PCB 38-6010 Rev. F

DESIGNATED PARKING CORP. CONFIDENTIAL		
Title :RRC MySpot 200 Controller 433/390MHz		
Size: Tabloid	433MHz Assembly 02-6010 390MHz Assembly 02-6012	REV: G2
	Date of Revision: Sept 14,2006	
	Document RRC_revG2.sch	
Sheet 1 of 1

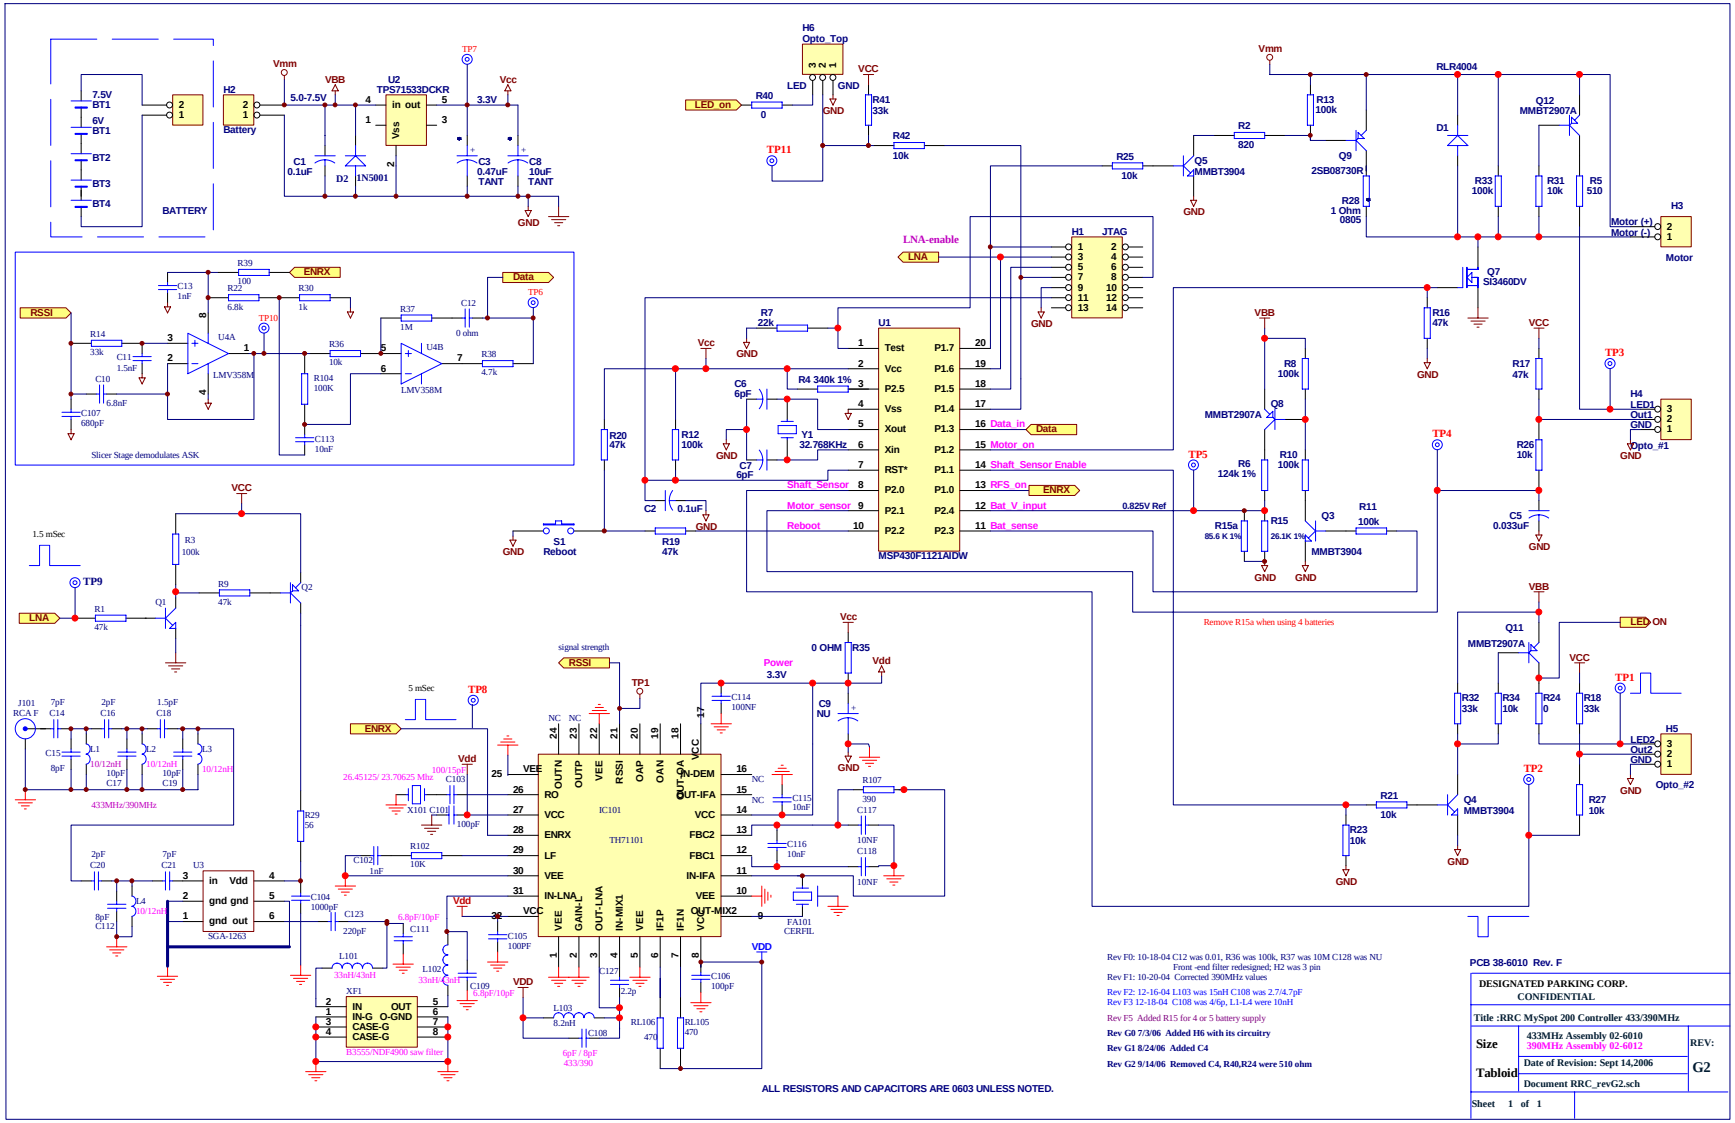
Rev F0: 10-18-04 C12 was 0.01, R36 was 100k, R37 was 10M C128 was NU
Front -end filter redesigned; H2 was 3 pin
Rev F1: 10-20-04 Corrected 390MHz values
Rev F2: 12-16-04 L103 was 15nH C108 was 2.7/4.7pF
Rev F3 12-18-04 C108 was 4/6p, L1-L4 were 10nH
Rev F5 Added R15 for 4 or 5 battery supply
Rev G0 7/3/06 Added H6 with its circuitry
Rev G1 8/24/06 Added C4
Rev G2 9/14/06 Removed C4, R40,R24 were 510 ohm
